SUBJECT: IP REQUEST FOR EXPERT REVIEW OF KRSKO PLANT CHANGES

DRAFT FSAR CHANGES

KRS10 FEEDWATER SYSTEM MODIFICATION

FOR SPLIT FLOW OPERATION

LOSS OF NORMAL FEEDWATER

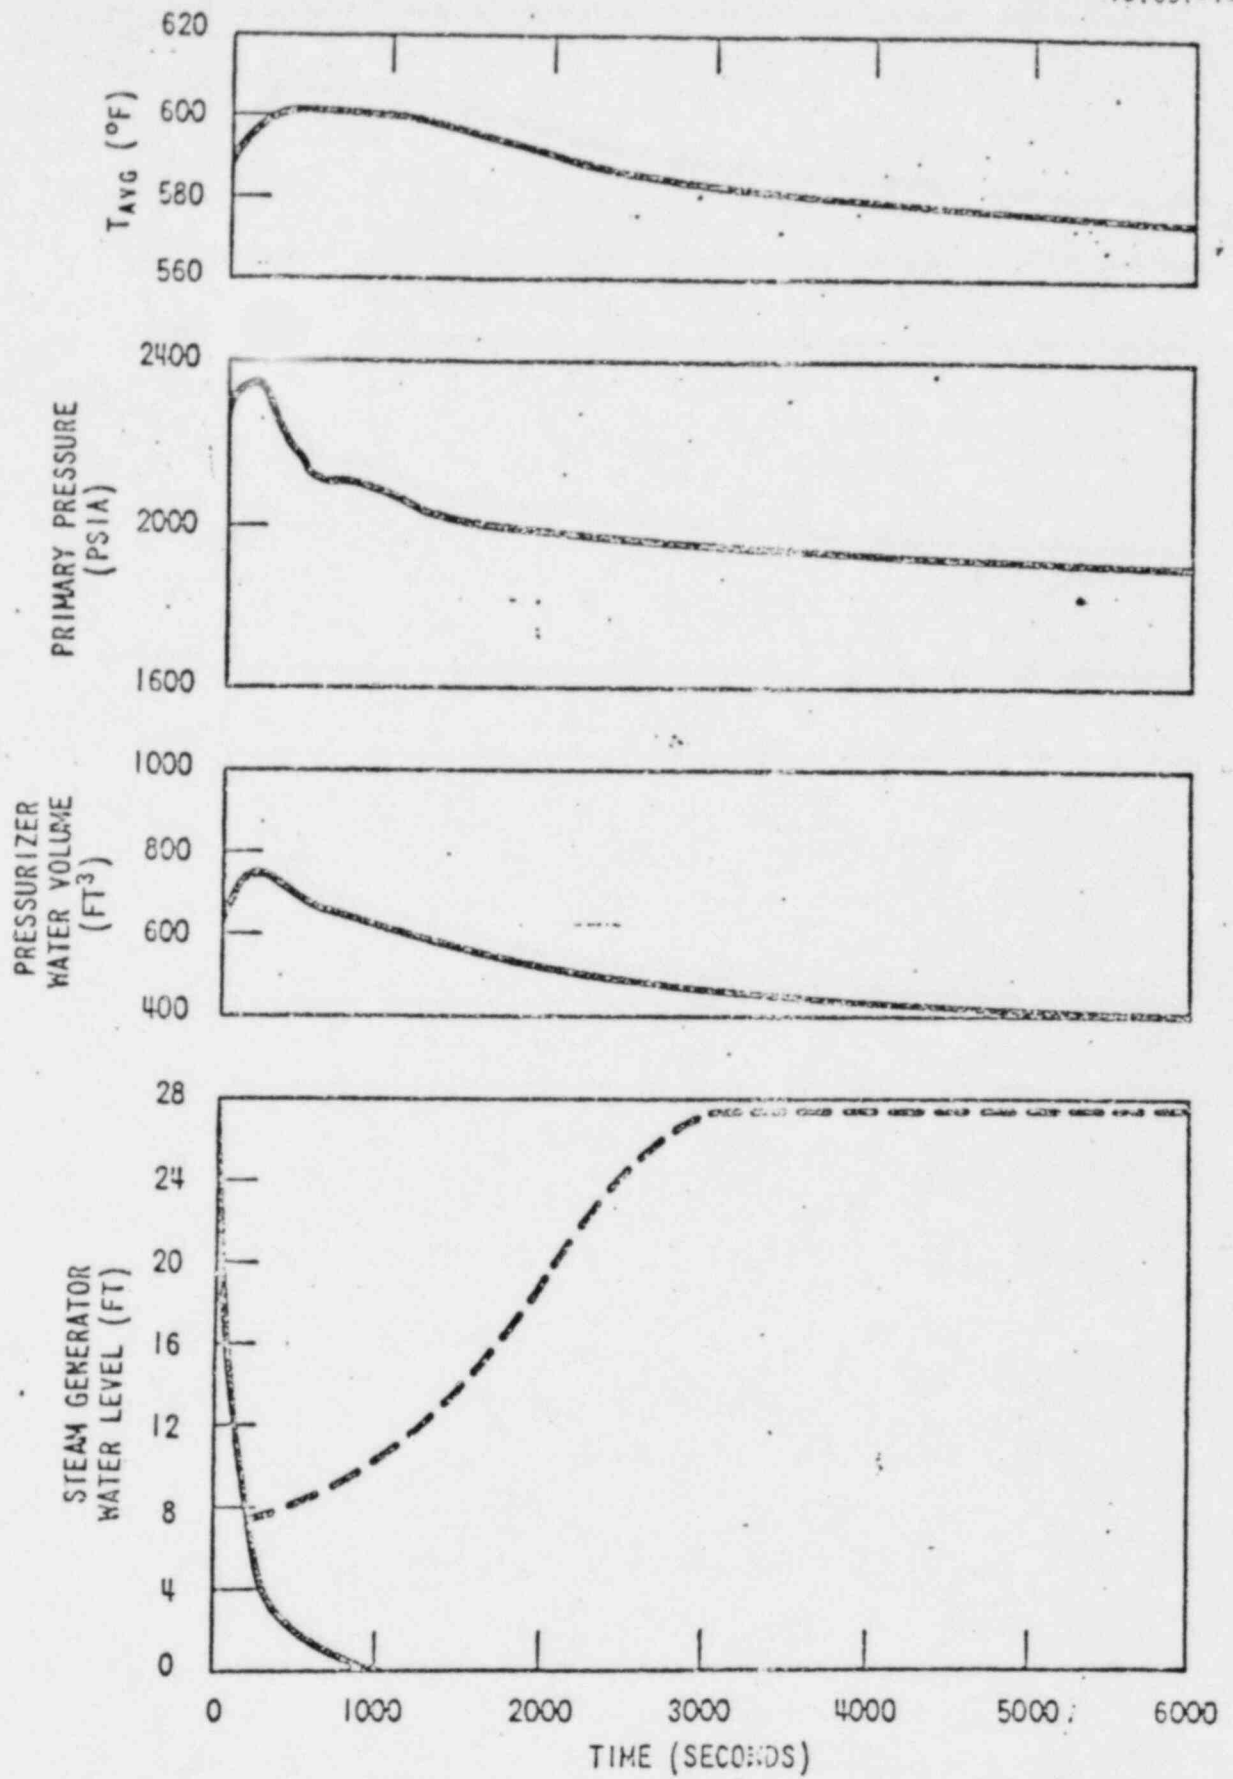
Replace with new figures

EXCESS FEED ACCIDENT FEED CONTROL
VALVE FAILURE AT FULL LOAD
NE KRSKO FSAR Fig. 15.2-25

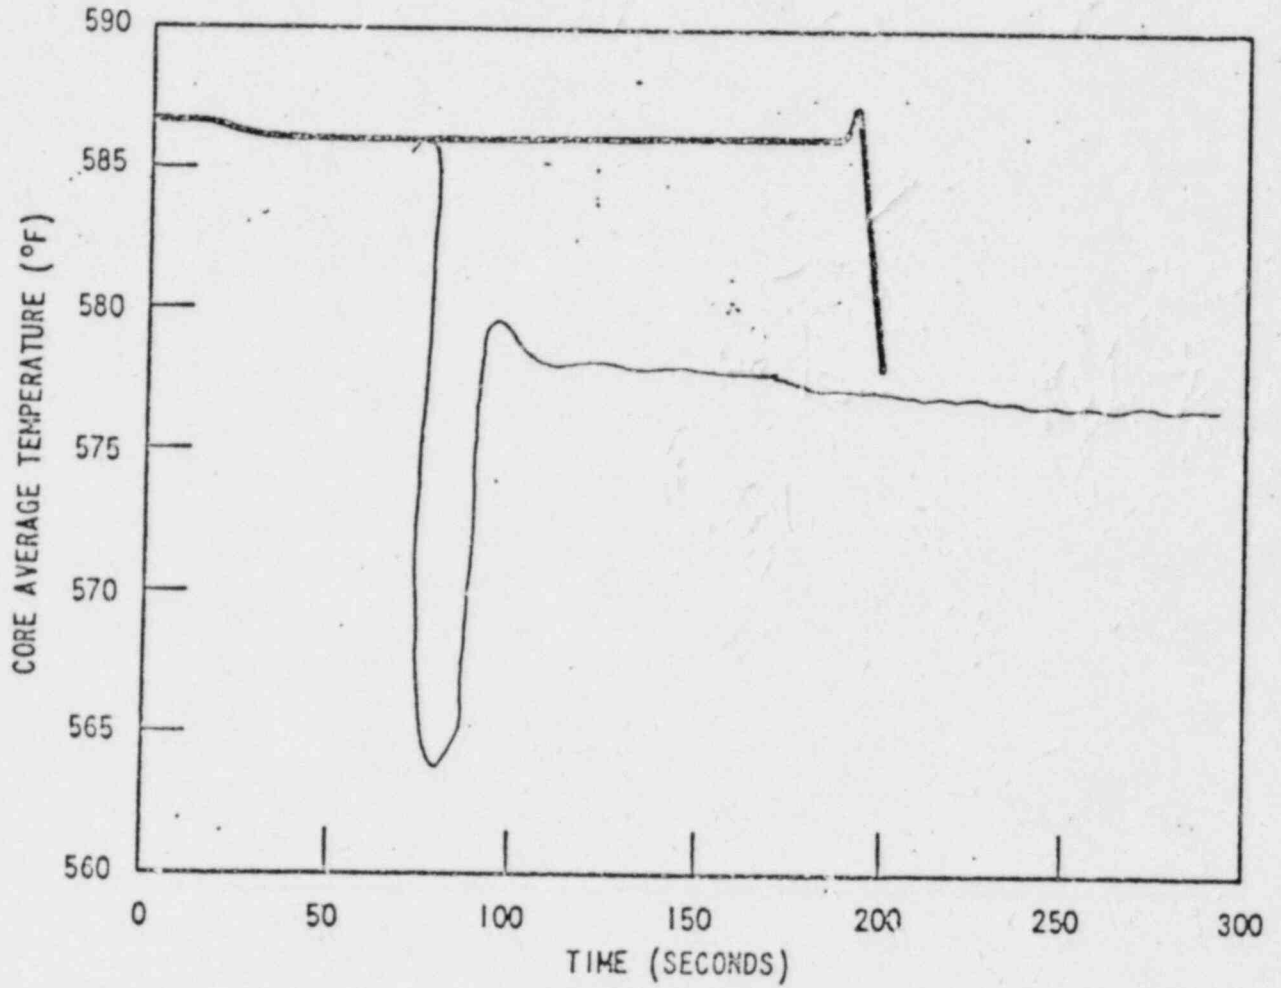
replace with new figure

EXCESS FEED ACCIDENT

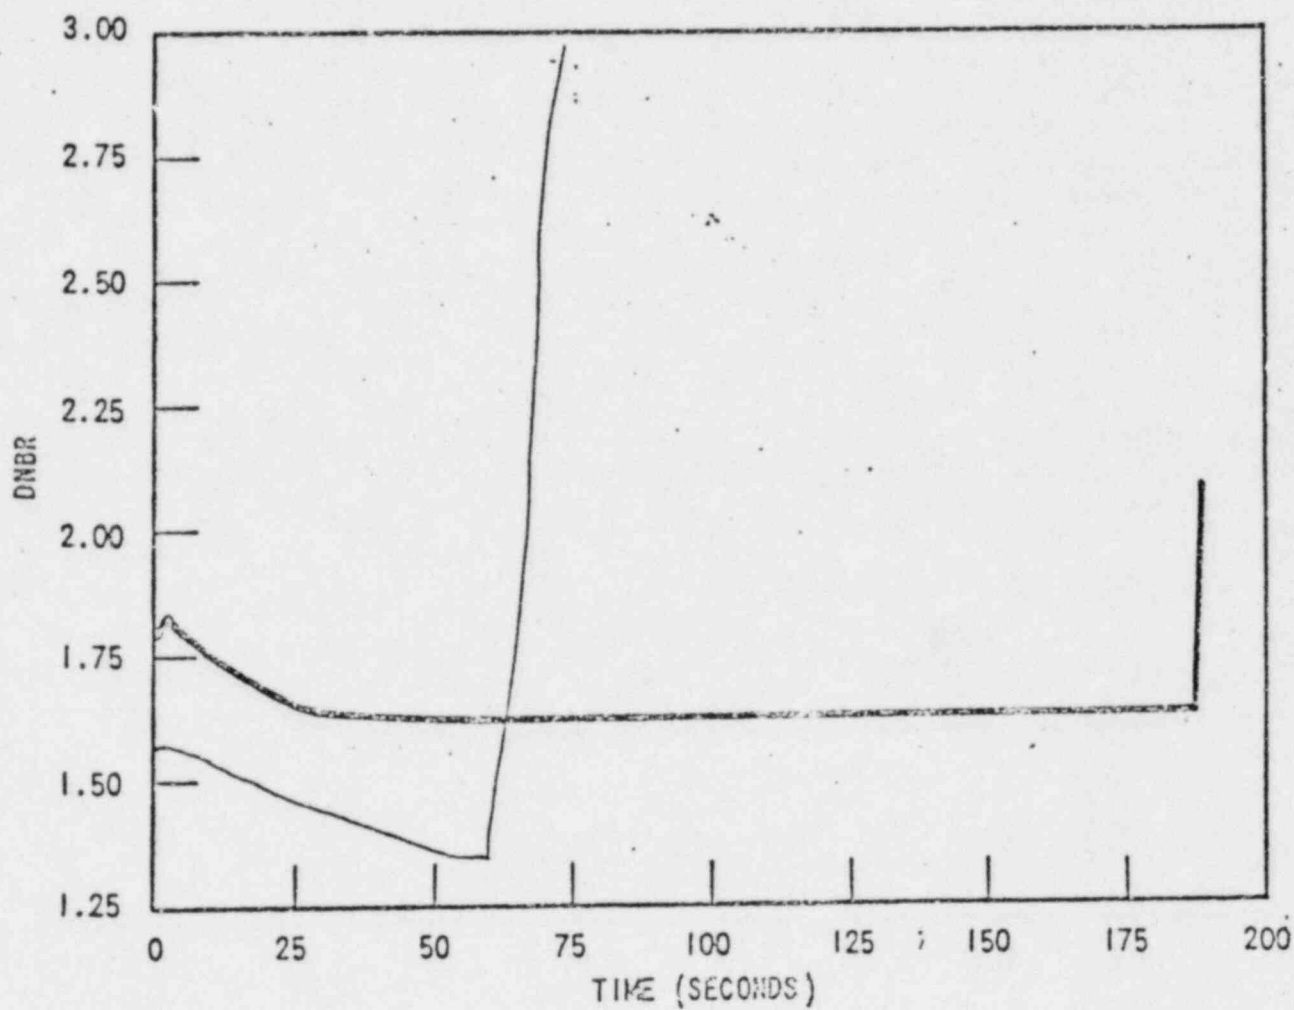
replace with new figure

FEEDWATER
 Sheet 1 of 2
 FSAR
 FIG. 10.1-3
 NE KRSKO

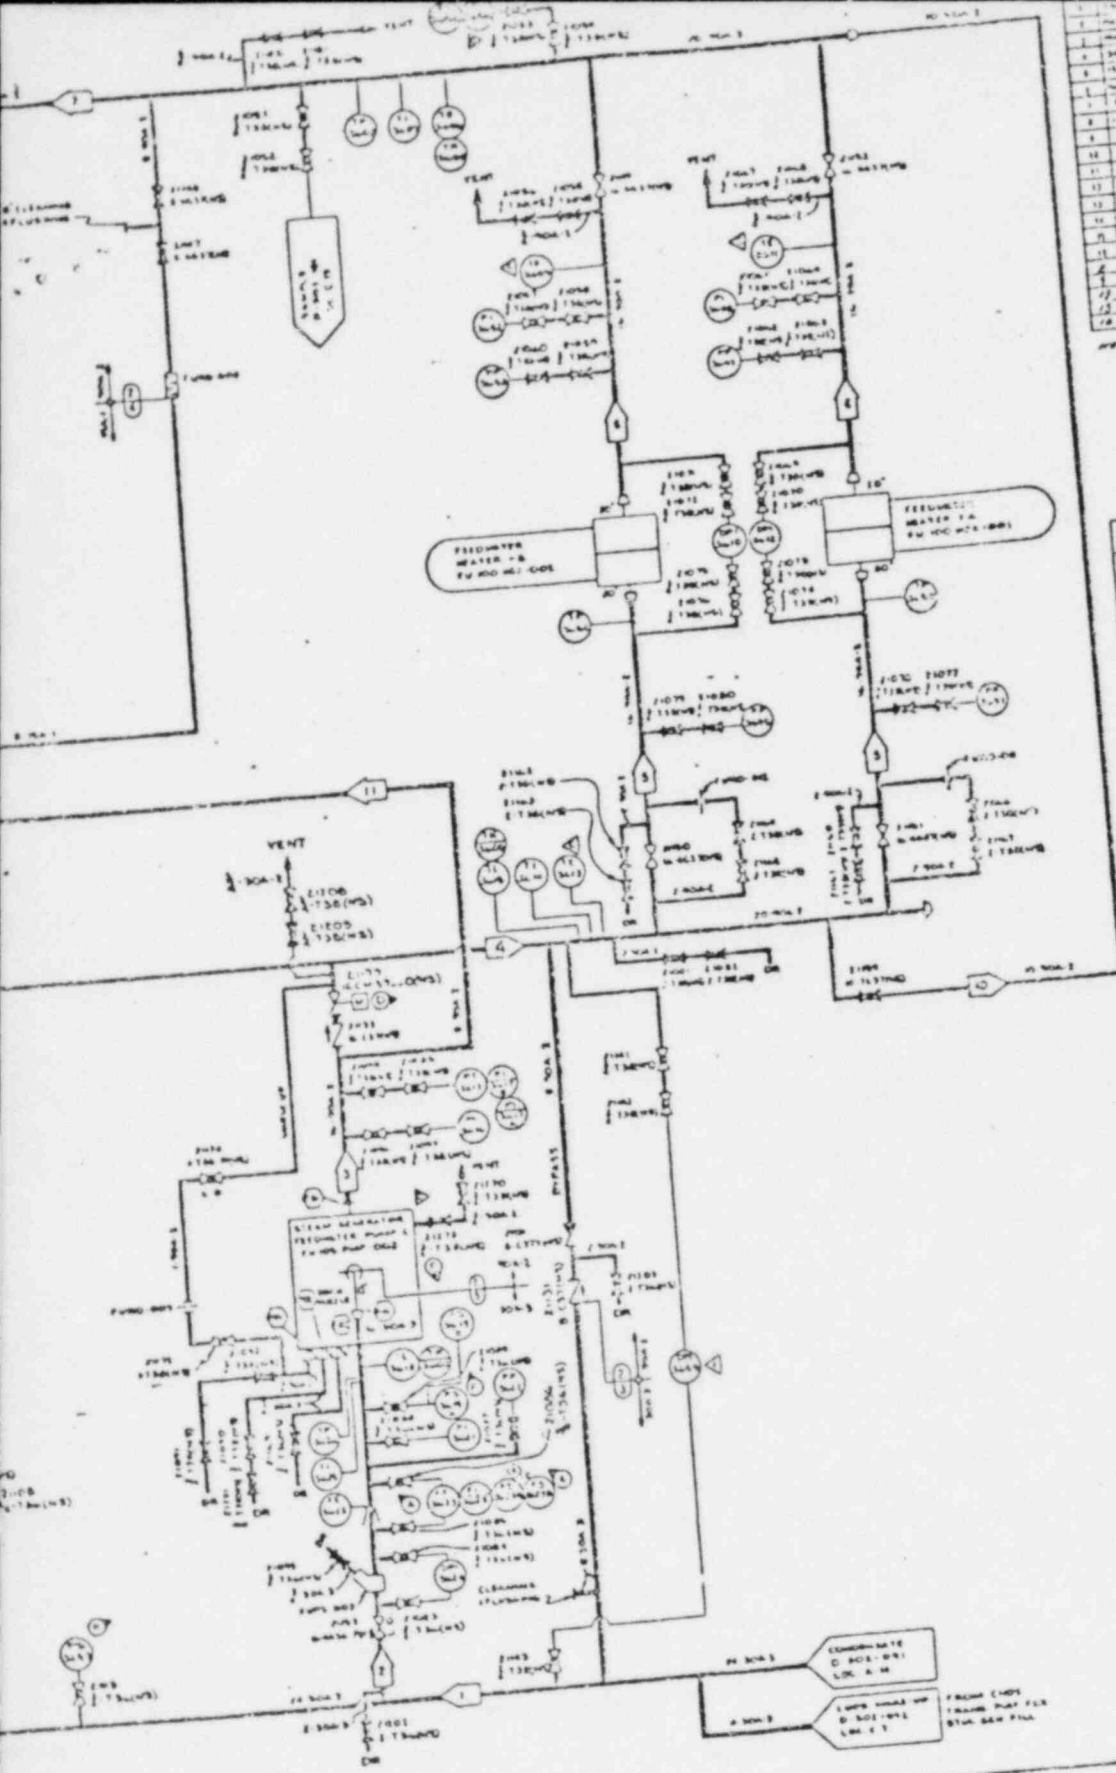
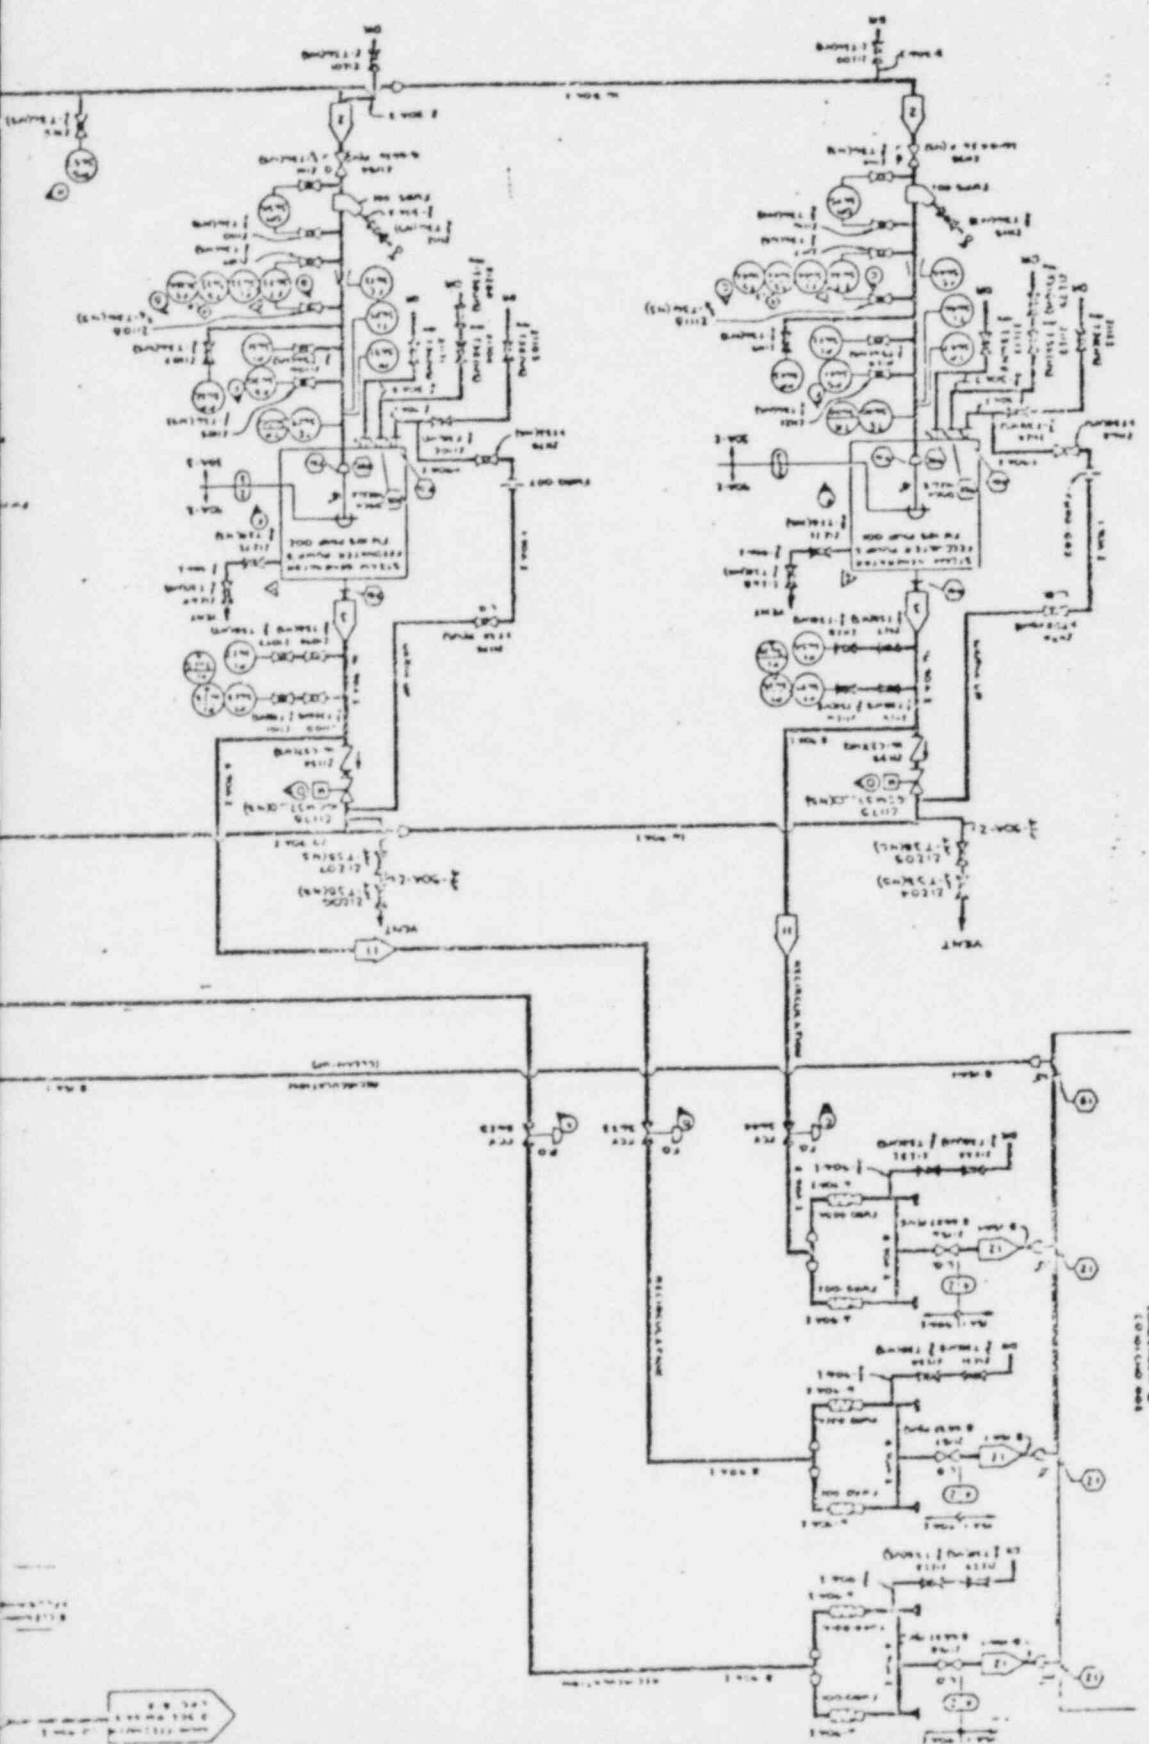
Add P&CV and lines
